Request for Class II Permissive Change(C2PC)

FCC ID: VG8XM136AYYW-PV5

This is a C2PC application for which the previous grant was issued on 07/11/2023.

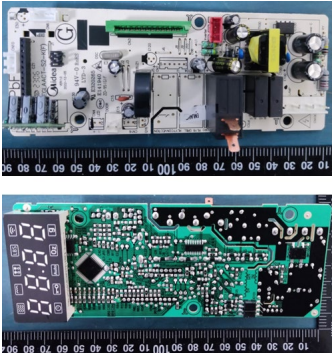
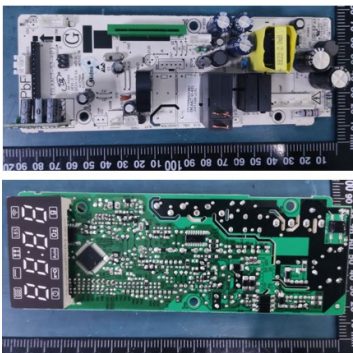
No.:	Original	New	Difference(s)
1			Keypad: Updated front keypad to accommodate child lock function (Child resistant oven door function)
2			Mother board: Modified the peripheral circuit (non-RF circuit) and some individual components and PCB layout. The magnetron and other circuit are exactly same as before
3	N/A		The new one adds a solenoid valve locking mechanism, the original is not.
